**PB# 00-202**

**First Columbia (SP)  
Hudson Valley Ave.  
Office Bldg.  
3-1-50**

**TOWN OF NEW WINDSOR**  
**PLANNING BOARD**  
**REVIEW COMMENTS**

**PROJECT NAME:** FIRST COLUMBIA SITE PLAN  
(1 HUDSON VALLEY AVENUE)  
(A/K/A NEW YORK INTERNATIONAL PLAZA)

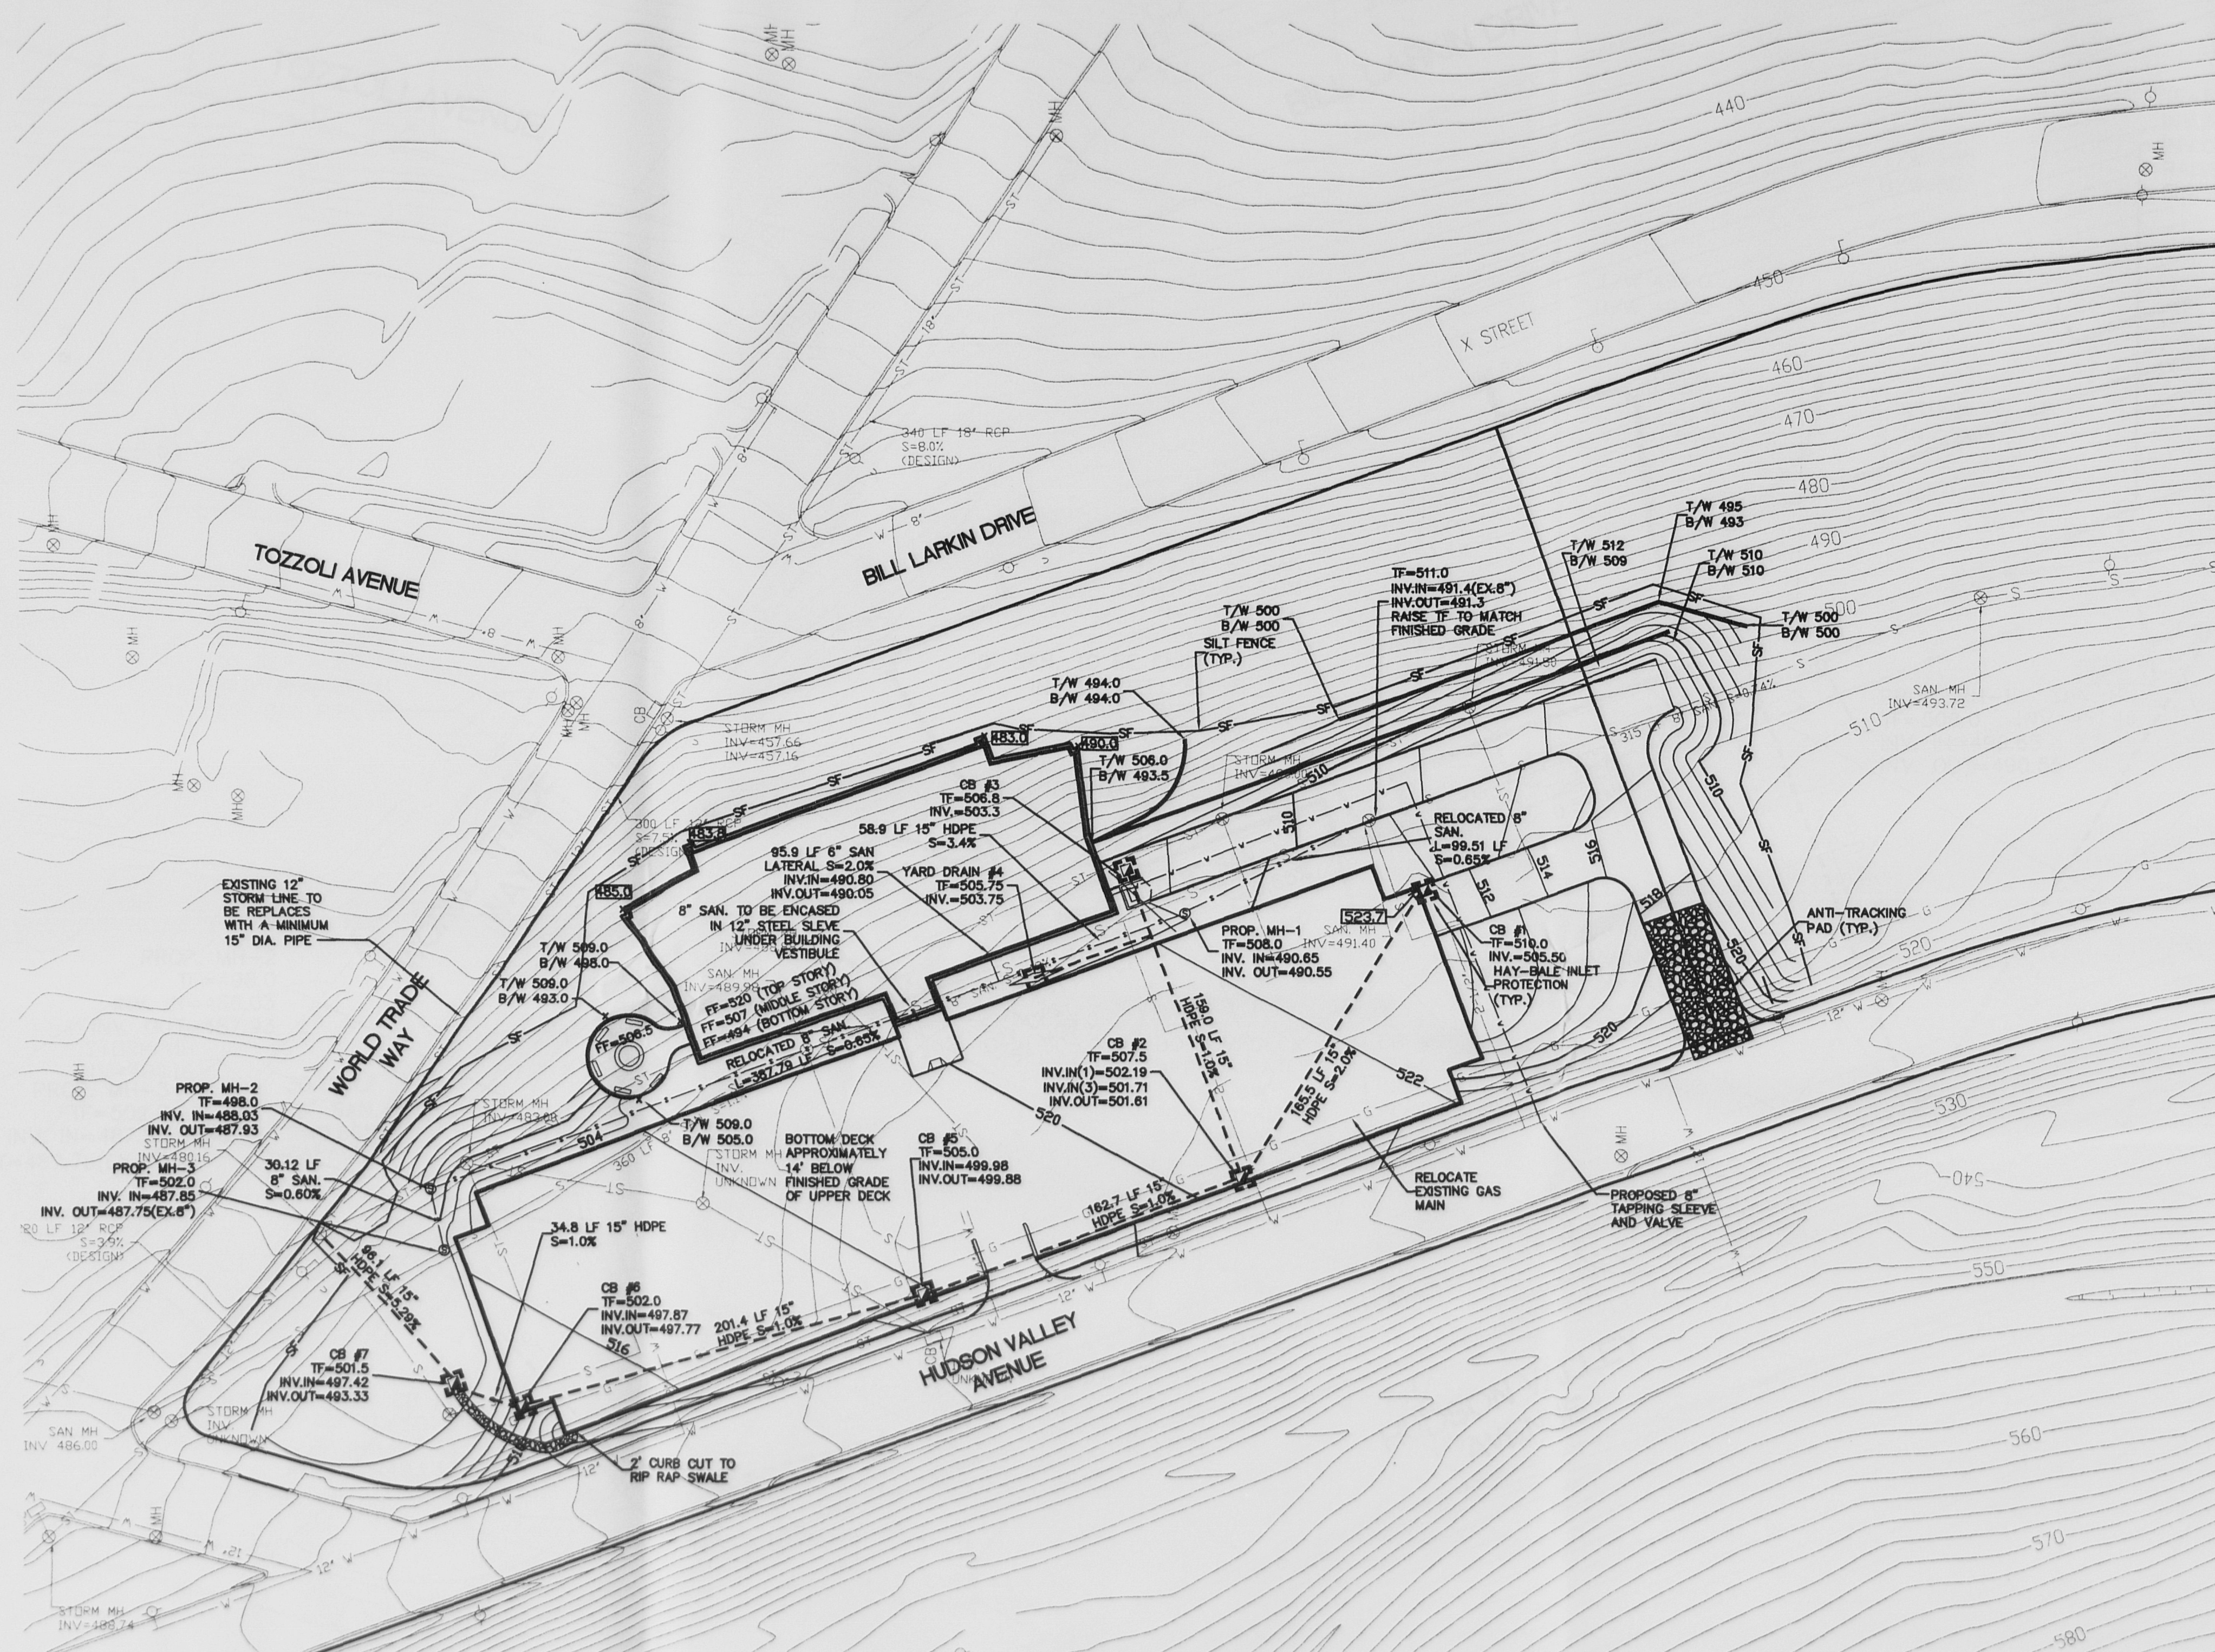
2. The Planning Board included a condition of approval that a note would be added to the plan regarding upsizing of off-site drainage piping as necessary. The note should be added to sheet GU-1, in a note "box" similar to the two notes already on the lower right hand corner of the sheet. The note should read:  
"The applicant will, in addition to the improvements shown on the plans, upsize the off-site drainage piping downstream of this site with piping in conformance with the Overall Drainage Master Plan for New York International Plaza, as approved by the Town. Timing for construction of these off-site improvements shall be as approved by the Town."

3. The note on sheet GU-1 regarding clearance for fire trucks should be revised. Change the sentence to read:  
"A minimum clearance of 12 ft. shall be maintained in all driving areas of the parking structure for access by fire and other emergency vehicles."

**LIGHT POLE & BASE**  
N.T.S.

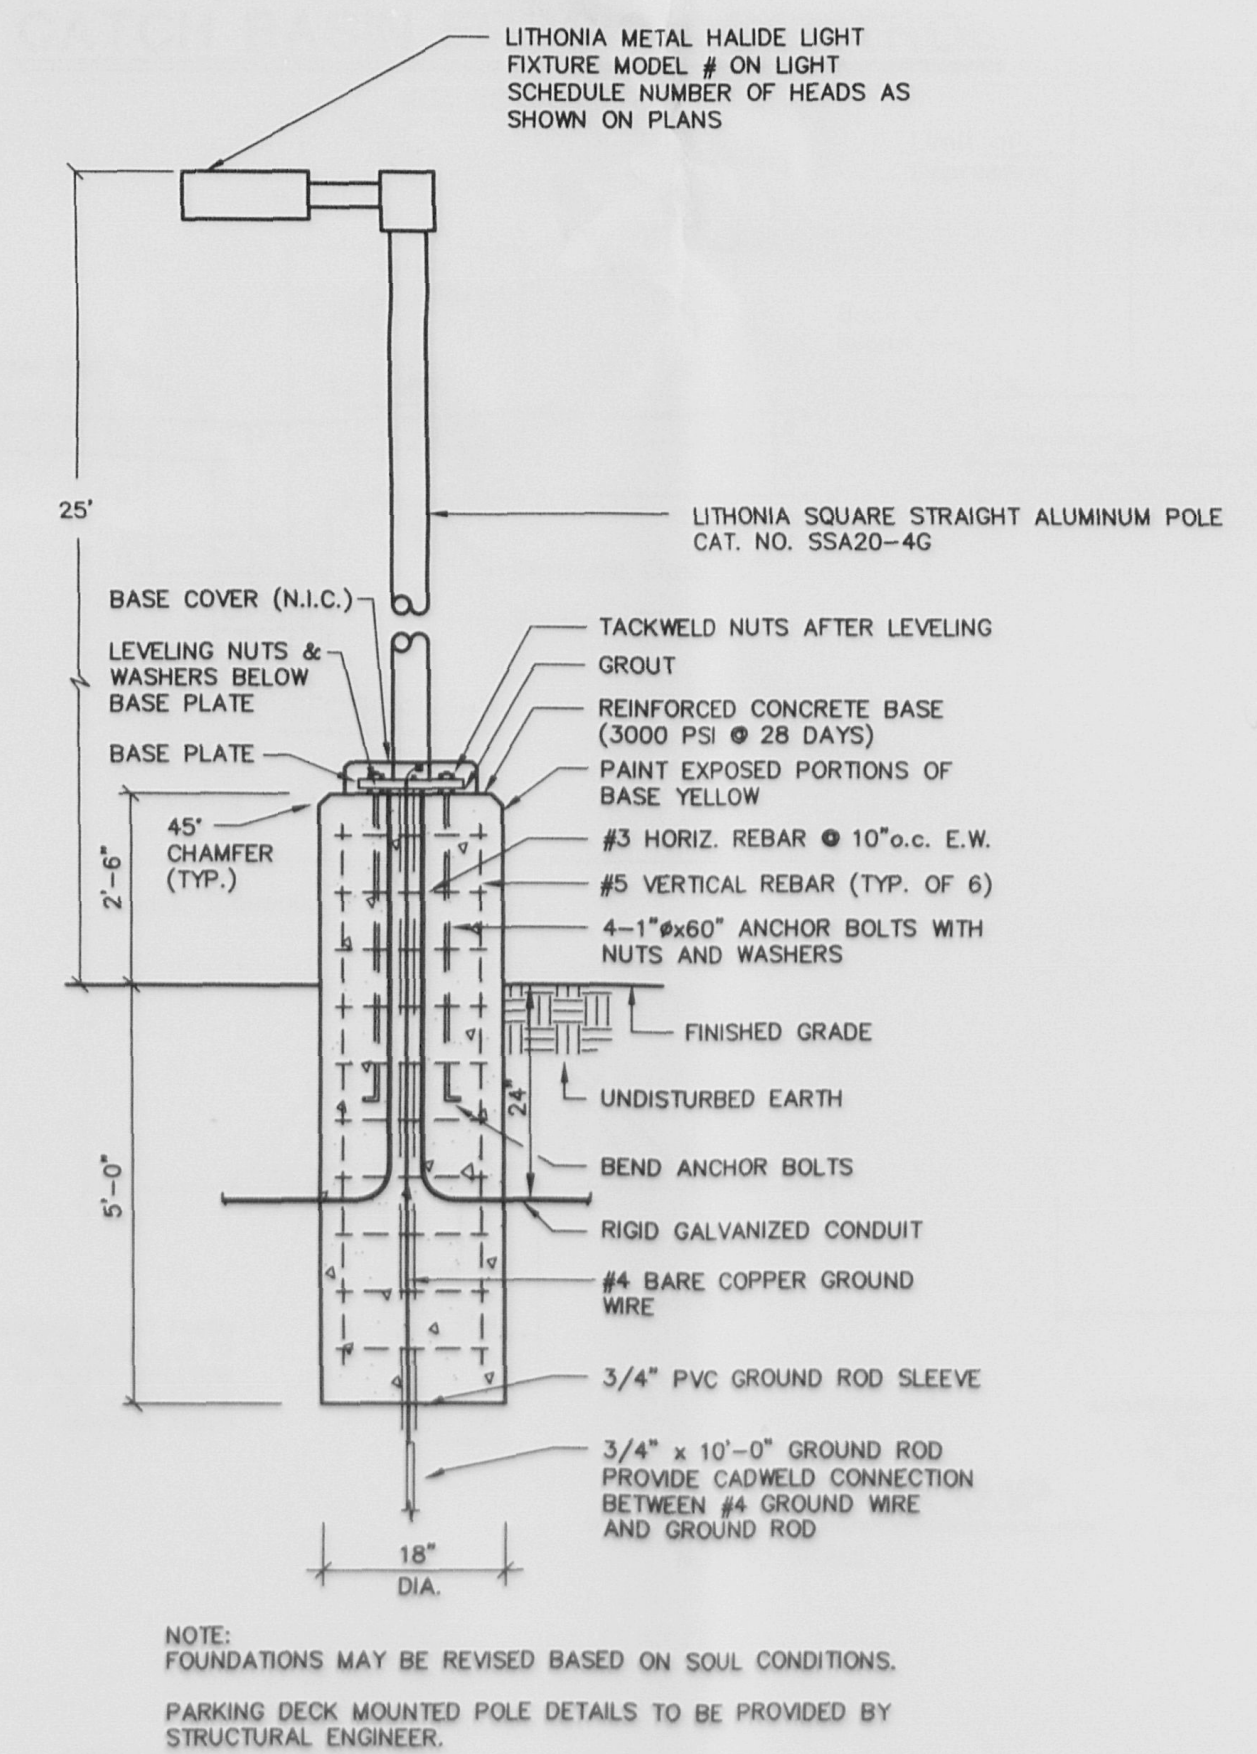
6. I have reviewed the lighting plan and same appears to provide a reasonable level of lighting at the site. The plan does not, however, deal with under parking deck lighting. I would assume that the building designer will deal with this. The fixture appears to be the preferred style of the Board and the unit is mounted at a reasonable height (25').
